Submission No: 165539

**Bimbi Pastoral Pty Ltd**

**Submission to the  
Independent Planning Commission on  
Thunderbolt Wind Farm SSD-10807896**

**FIGURE 1**

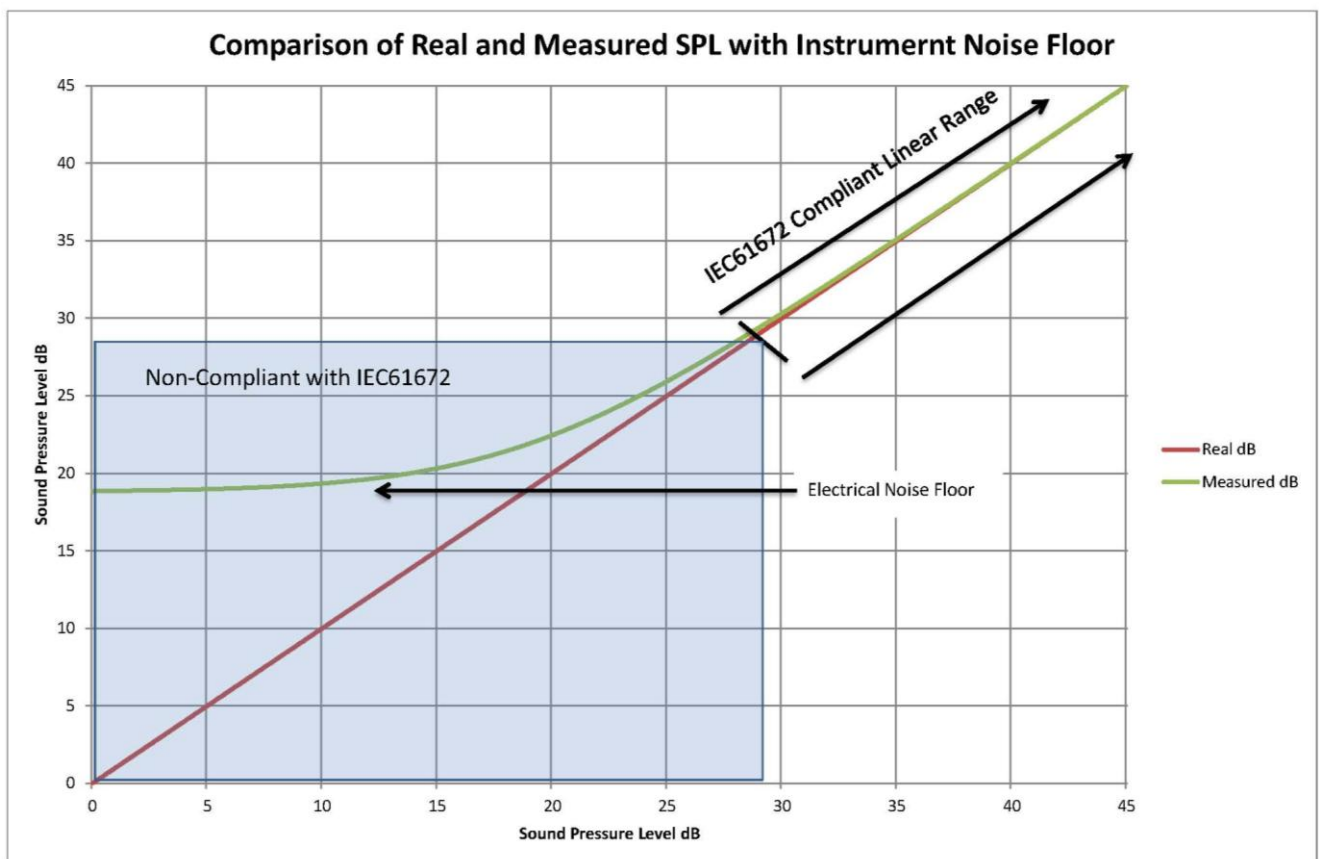
Data presented in wind farm noise assessment reports that are below the lower measurement range of the instrument are not compliant with the specification requirements of IEC 61672. Figure 1 shows the compression effect that sound level meters have as the sound levels approach the instrument noise floor.

The question then arises; how representative are these background curves upon which compliance limits are set? Figure 18 of the Supplemental Guideline Note 2 shows data clearly influenced by the instrument noise floor. In this example, the data limits at around 18 dB(A) and if instrumentation such as the CESVA 310 or Rion NL31 were used to gather this data then the valid data (compliant with IEC 61672) would only be above 28 dB(A).

**FIGURE 2**

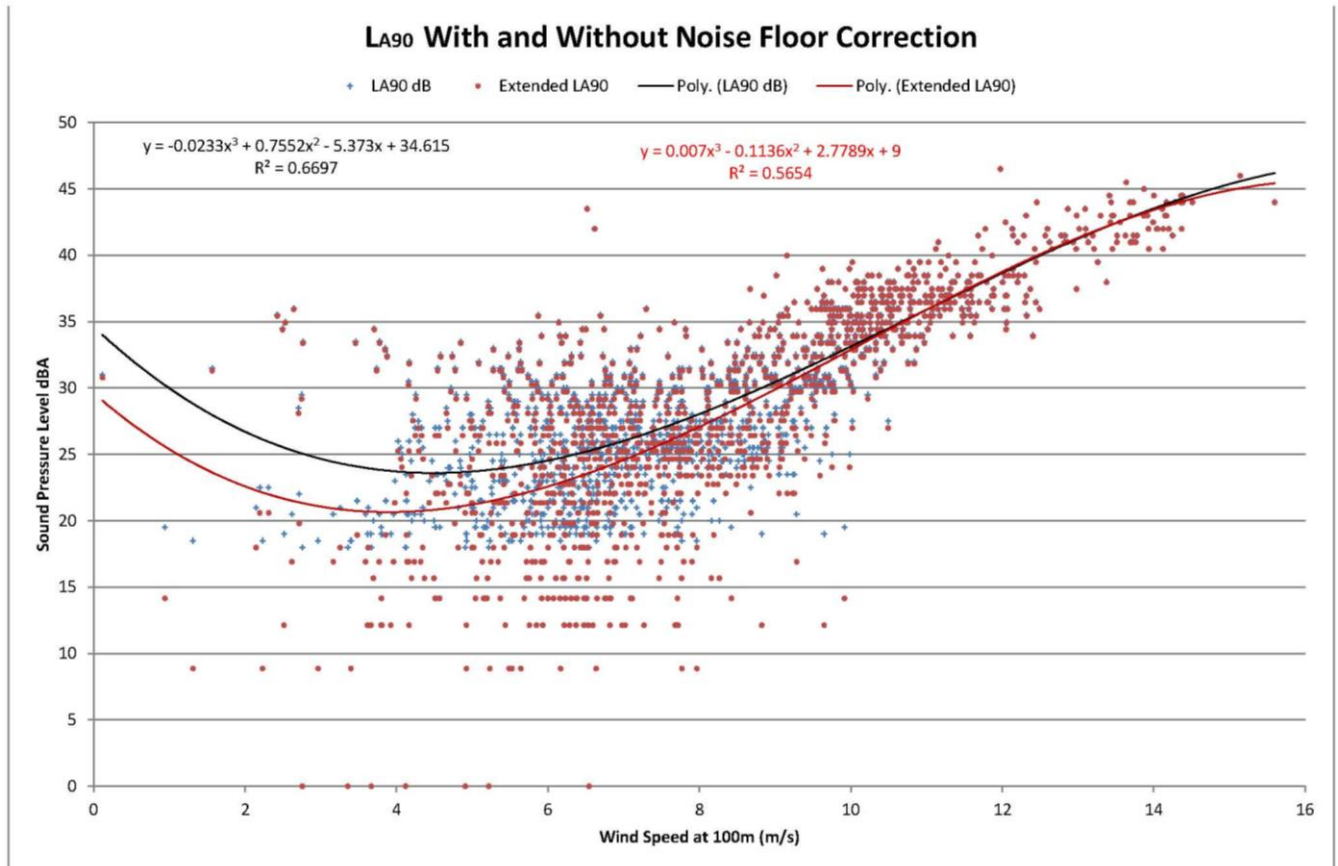
The chart in Figure 2 provides an example of such a crude correction on data taken with a CESVA 310 sound level meter. The corrected data is shown as 'Extended LA90'. A simplistic trend analysis is shown in accordance with the IoA Good Practice Guide Supplementary Guidance Note 2.

A 'Flat Lined Background Noise Level'<sup>17</sup> at lower wind speeds would be approximately 3dB higher with uncorrected data. Different measurement data can show a larger discrepancy than 3dB.

**FIGURE 3**

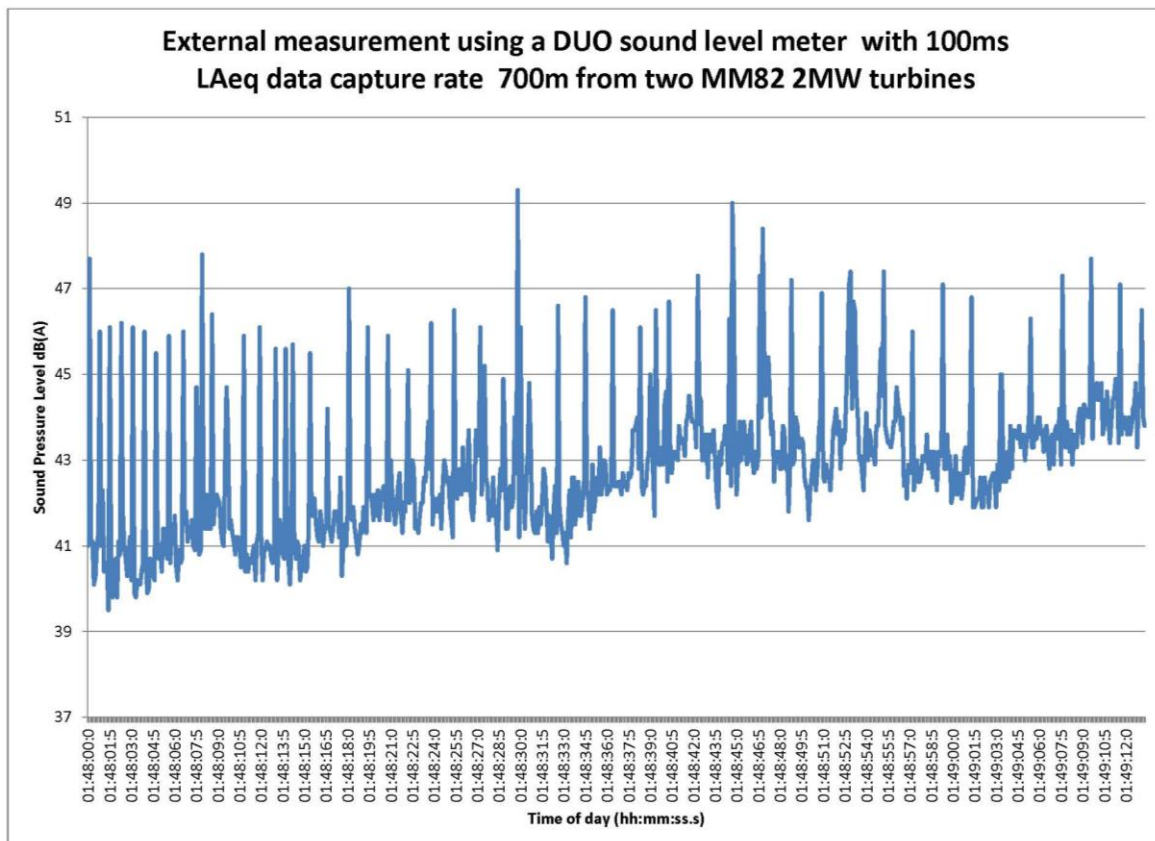
AM does not generally have a sinusoidal pattern and can have dips within each modulation. Time traces of A-weighted sound levels exhibiting AM from wind turbines can be very complex. When there are multiple turbines the AM patterns are even more complicated. Figure 3 shows a 72-sec time trace 700m from two MM82 wind turbines.

The AM repetition at the start of the time trace in figure 3 is around 2 Hz but AM peaks can be separated by <1ms to 1.2s (blade pass frequency) as the phase between the rotors change. In such circumstances a Fast response may greatly underestimate the real magnitude of AM.

A better method of tracking the real AM would be to use short Leq values that are available from many modern integrating sound level meters. Alternatively, sample the output from the DC connector if the output is derived directly after the rms detector, before any slower time constant is applied (eg. Larson Davis 700 and 800 series meters).

Fig. 12-1 Frequency weighting A

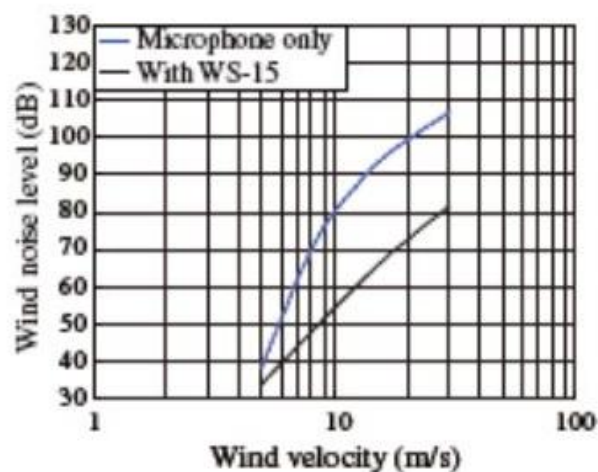
Extrapolating the local wind speed velocity to 4 m/s it is expected that wind generated artificial noise on the microphone is 30 dBA. Such influences on the measured Background noise measurements are required by SA 2009 to be addressed in the development application (EIS).

The Sonus report states that measured sound levels in local wind speed above 5 m/s were discarded but the report does not describe how the wind speed below 5 m/s affects the measured results. For equipment using the WS-15 wind screen it would be appropriate to correct measurements with local wind speeds around 4 m/s generating artificial noise around a level of 30 dBA, as described in SA 2009 as follows:
